66309B-05

S E R V I C E N O T E

66309B

Reliability Improvement of Instrument

CORRECT J207 PLACEMENT – alignment to within $< 0.3\text{mm}$

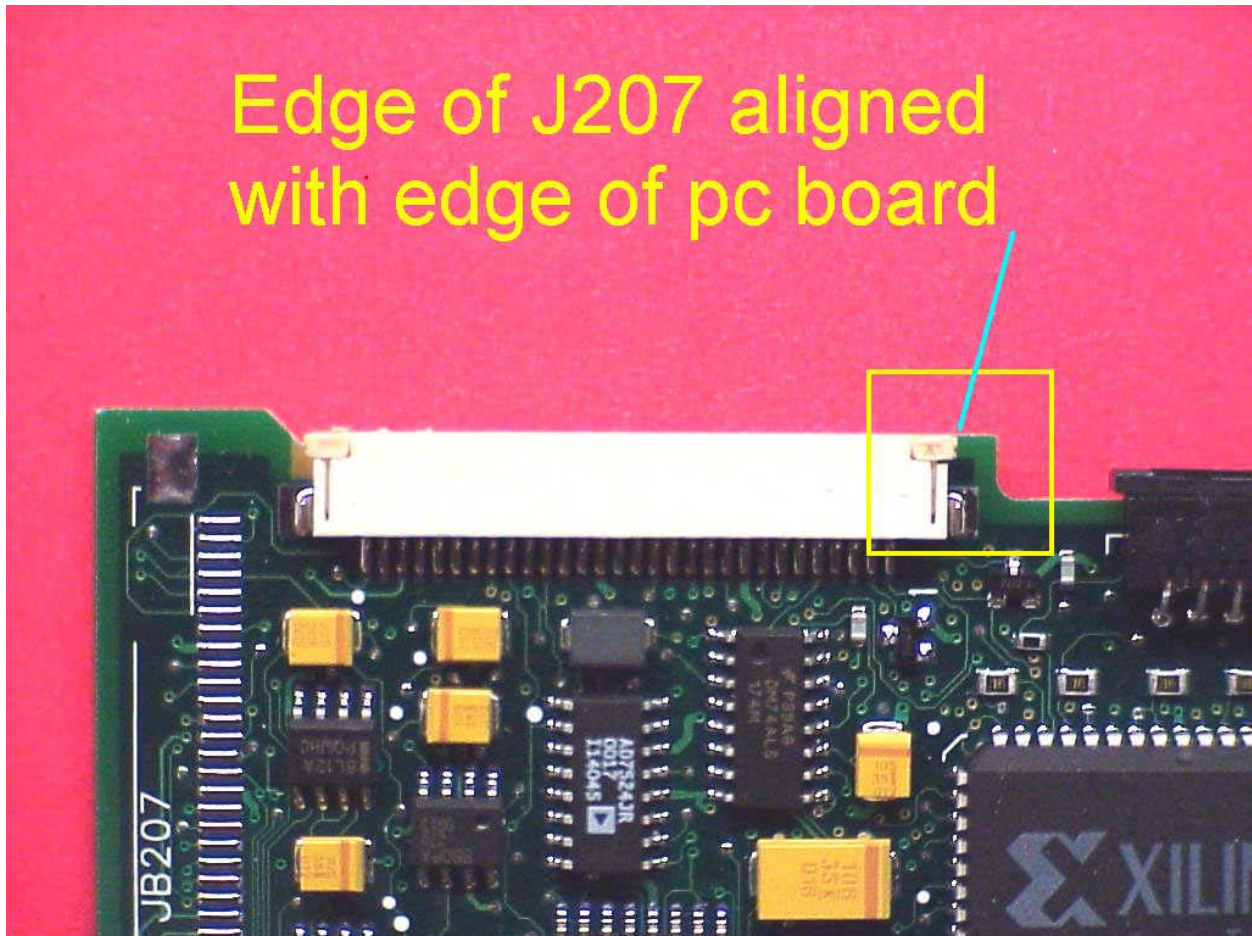
Latent product failure due to misplaced connector J207 on SMT assembly 5064-0018 (GPIB/RS232 interface). Misplacement of J207 could lead to inadvertent contact/shorting of exposed feed-throughs on SMT board. Ultimately, resulting in over-stress of components of damage to SMT board components. Resulting contact could degrade useful life of instrument.

Picture shows connector aligned to edge of SMT board to within $< 0.1\text{mm}$

- 1) Compare placement of J207 to attached photos. Instruments with a “misplaced” J207 should be returned to Agilent for warranty repair.
- 2) Instruments returned to the Service Center for routine calibration should be inspected for this potential defect. Defects should be addressed using Agilent’s unit exchange process with costs being charged to warranty.
- 3) The factory has modified production documentation to include visual inspection and specific electrical testing for this potential short.
- 4) Factory is maintaining feedback to SMT board supplier regarding quality of assembly.

INCORRECT J207 PLACEMENT – misaligned by $> 0.3\text{mm}$

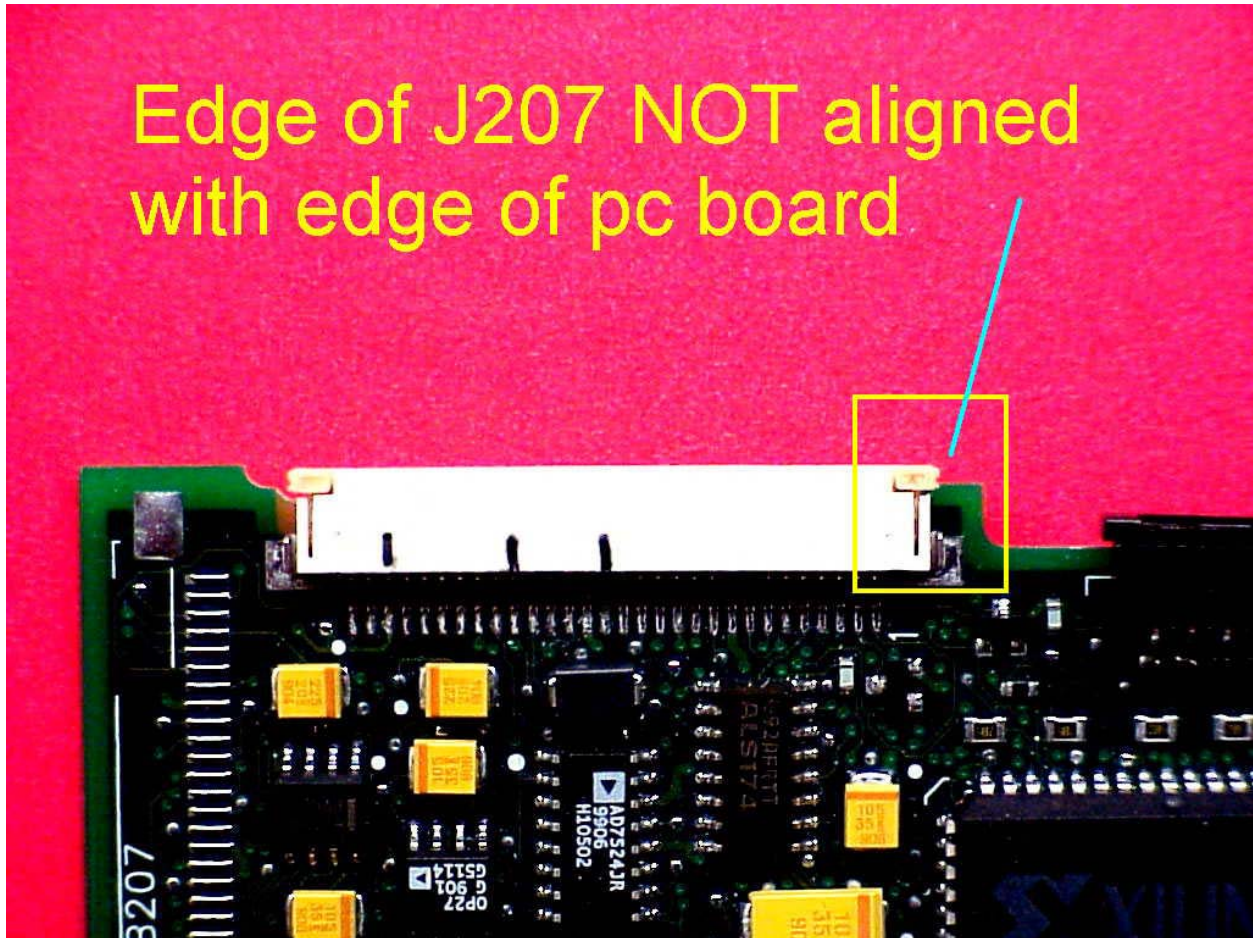
Picture shows connector extending past edge of SMT board by $>1.2\text{mm}$
